# TPS Transport Consultants Ltd

## Road Safety Audit Response Report

Client	Avant Homes
Project	Barugh Green Road, Barnsley
TPS Reference	P2636
Date Prepared	04.09.25
Prepared By	JT
Checked By	JA

**Road Safety Audit Stage 1**

Site layout plan provided for RSA1

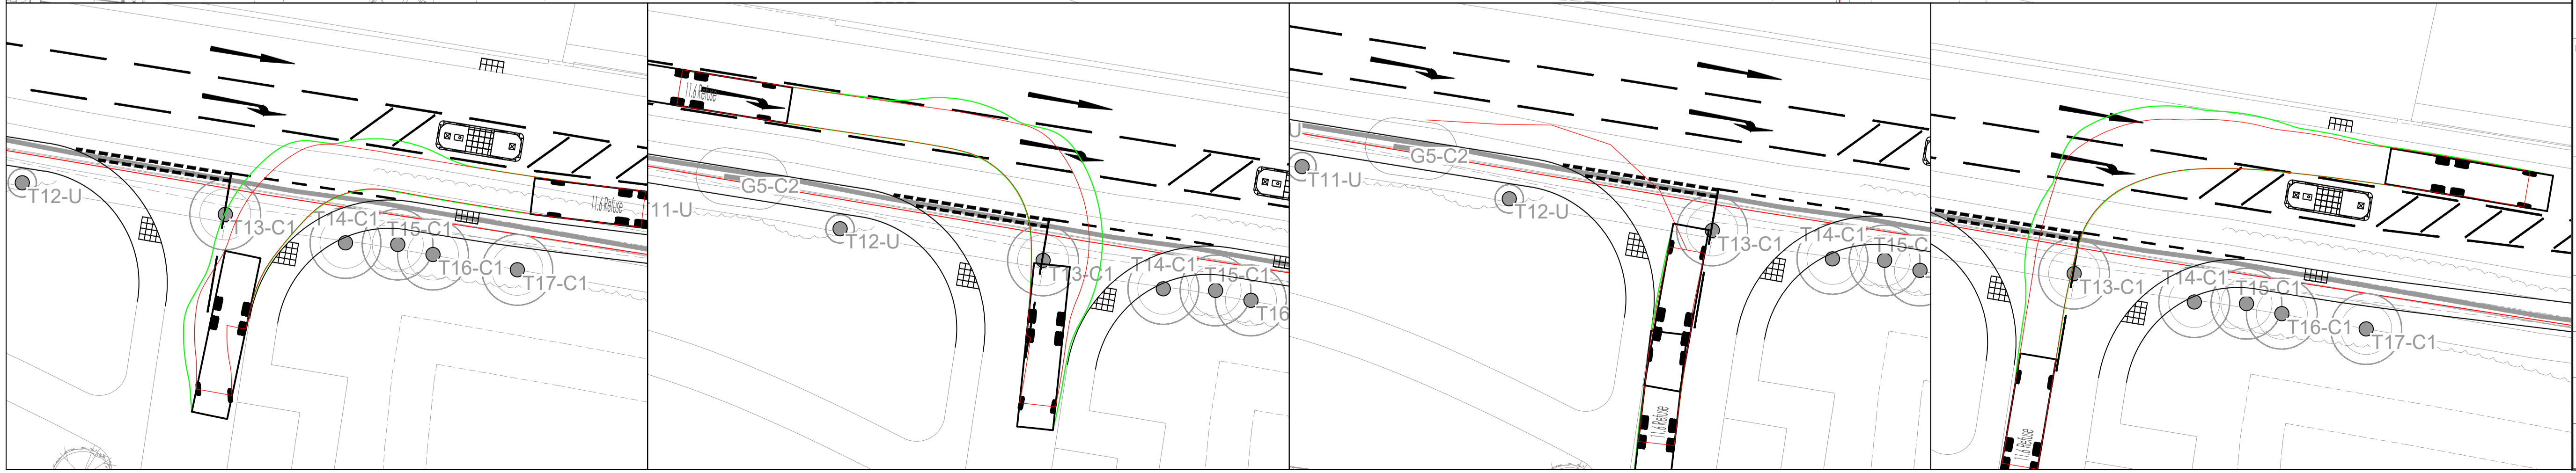
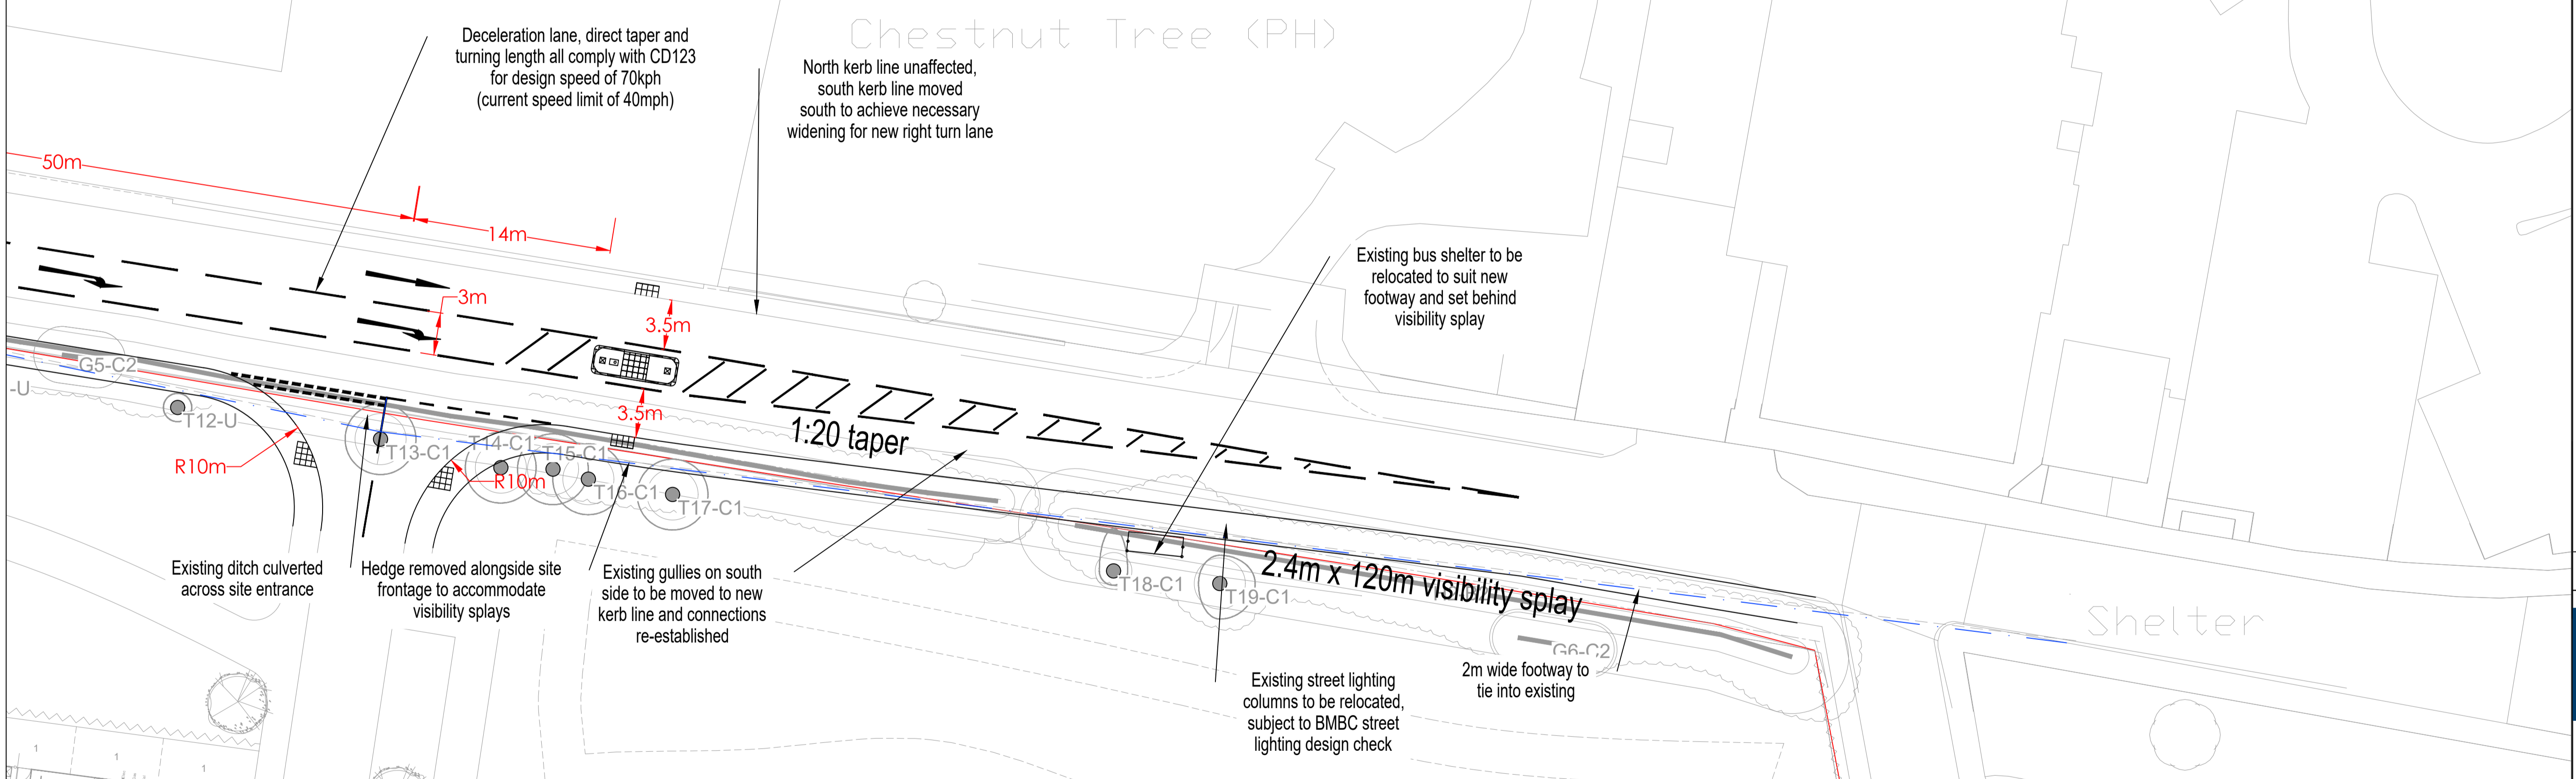
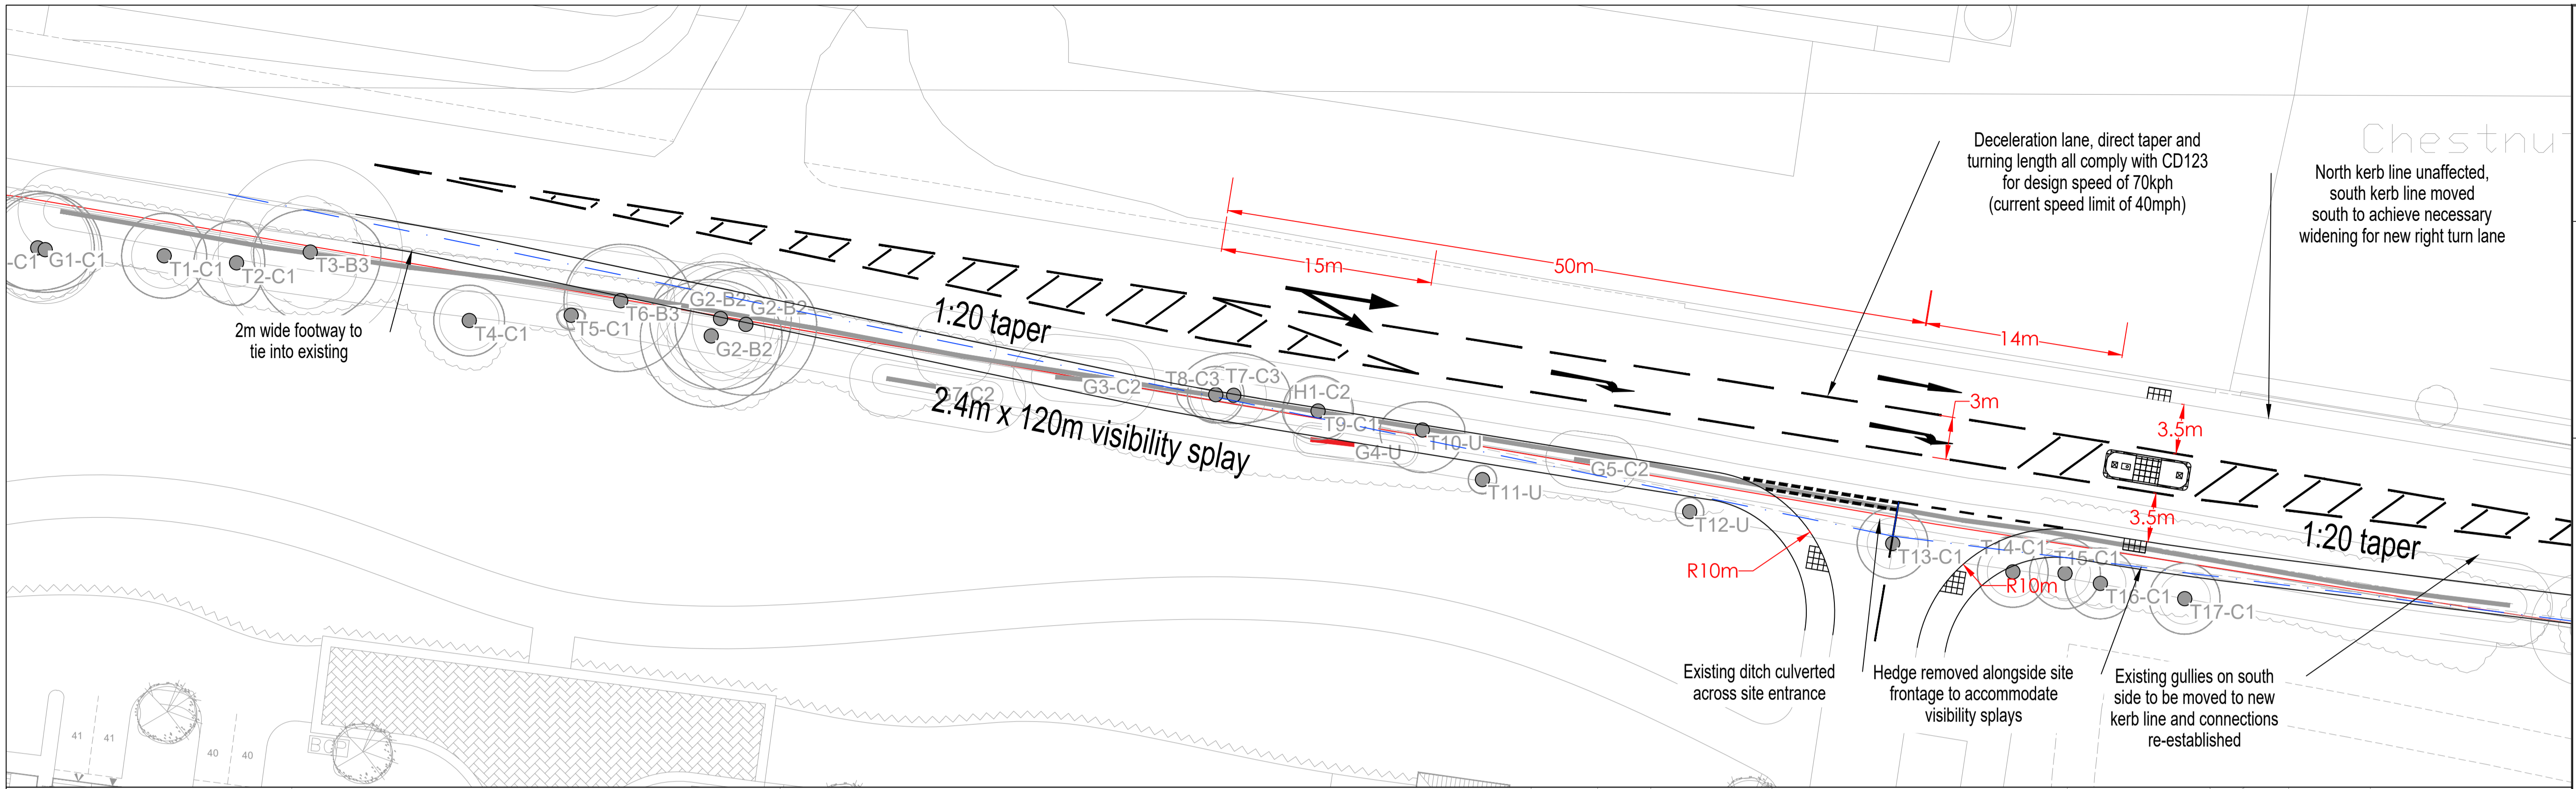
RSA Problem	RSA Recommendation	Design Organisation Response	Overseeing Organisation Response	Agreed RSA Action
<p>A-01 – Barugh Green Road – Development access and main carriageway</p> <p>Drainage – Insufficient surface water drainage may increase the risk of skidding type collisions at the junction as well as slips and falls by pedestrians.</p> <p>At this early stage, no details have been provided on the proposed drainage arrangements. The site appears to raise up to a higher level than the main carriageway. As such, this may require measures to manage surface water around the junction to reduce the risk of surface water from the development entering Barugh Green Road or standing water and detritus in the junction area that may consequently cause skidding type collisions near the junction or slips and falls by pedestrians crossing in this area.</p>	<p>It is recommended that drainage details are provided at the next stage of road safety audit including gully locations, levels and contours.</p>	<p>Agreed.</p> <p>As part of the S278 package of drawings, drainage details will be provided, and this will be covered by the Stage 2 RSA.</p>

<p>A-02 - Barugh Green Road – Main carriageway.</p> <p>Skidding Resistance – Carriageway surfacing across part lane widths may increase the risk of loss of control type collisions.</p> <p>The drawings indicate that carriageway widening is to be provided with no indication of resurfacing of the existing carriageway nor what skidding resistance is to be provided. There is a risk here that, if widening is provided by means of haunching the carriageway width into the verge, a differential skidding resistance is introduced between the new and old carriageway surfacing. This difference in skidding resistance may increase the risk of loss of control type collisions, especially when the carriageway surface is wet.</p>	<p>It is recommended that the widening provided is done so in full lane widths and the revised crown of the road is located such to avoid the application of any adverse camber.</p>	<p>Agreed.</p> <p>As part of the S278 detailed design, it will be specified that resurfacing is done across the full width of the carriageway over the length of the proposed works.</p>

<p>A-03 – Barugh Green Road – Southern verge area</p> <p>Fences and Road Restraint Systems – Lack of barrier protection to the drainage ditch may increase the risk that pedestrians or other road users enter the ditch and sustain injuries or drown.</p>	<p>It is recommended that a barrier treatment proportionate to the level of risk is provided between the drainage ditch and areas where pedestrians and other road users may be. This could be as simple as a fence</p>	<p>Agreed.</p> <p>As part of the detailed design of the proposals, consideration will be given to an appropriate protection to separate users of the footway from the ditch. This</p>

<p>A-04 - Barugh Green Road – Main carriageway.</p> <p>Speed Management – Speed limit may increase the injury severity in the event of a collision involving a pedestrian or other active mode.</p> <p>The road frontage environment will change considerably with the development. There will also be an increase in pedestrian and possibly cyclist activity crossing and walking alongside Barugh Green Road. The development will likely create increased crossing desire for the bus stops, the supermarket and the public house. Should the existing 40mph speed limit be retained along Barugh Green Road, there may be a risk of increased injury severity in the event of a collision involving a pedestrian or other active mode.</p>	<p>It is recommended that the existing 40mph speed limit along Barugh Green Road is reduced to 30mph.</p>	<p>Agreed.</p> <p>The speed limit along Barugh Green Road is to be reduced to 30mph. This will commence from the A635 at the roundabout junction with Whaley Road to the east and continue along the site frontage to the western boundary of the site. Details of the appropriate signage and gateway features to be provided as part of S278 detailed design.</p>

<p>A-05 - Barugh Green Road – At the proposed crossing.</p> <p>Pedestrians – Lack of footway space at the dropped crossing may increase the risk of pedestrians and other active modes being involved in a collision on the main carriageway.</p> <p>The footway along the northern side of Barugh Green Road is narrower than what would be considered desirable. This is exacerbated by a kerbed feature to the back of the footway. This may increase the risk of congestion around the dropped crossing point and make manoeuvring mobility scooters and wheelchairs</p>	<p>It is recommended that the proposed pedestrian refuge is relocated marginally east to the supermarket pedestrian access where there is additional space at the back of the footway. It is also recommended that negotiations are entered into to establish if widening of the footway behind the highway boundary can be provided.</p>	<p>Agreed.</p> <p>The drawing attached at <b>Appendix C</b> demonstrates the revised location of the proposed crossing facility to the location suggested by the audit team.</p>

<p>more difficult. This may consequentially increase the risk of pedestrians and other active modes stepping into the main carriageway near the dropped crossing point and being struck by a passing vehicle.</p>				
<p>A-06 – Barugh Green Road – At the pedestrian refuge</p> <p>Lighting – Insufficient carriageway surface illumination may increase the risk of collisions involving pedestrians during the hours of darkness.</p> <p>There is currently street lighting provision in the vicinity of the proposed pedestrian refuge. This is likely to provide a standard level of carriageway illumination for a commercial frontage. The introduction of a refuge will focus pedestrians to cross at this location where pedestrians may not have enough contrast against background light from the adjacent development and vehicle headlights. Insufficient carriageway surface illumination at the crossing point may increase the risk of collisions involving pedestrians during the hours of darkness.</p>	<p>It is recommended that carriageway surface illumination is provided to a higher class/level in the vicinity of the proposed crossing point. This may be as simple as increasing the output from the existing LED luminaries.</p>	<p>Agreed.</p> <p>As part of the S278 detailed design of the access street lighting will be considered to ensure that the crossing point and access is sufficiently illuminated.</p>
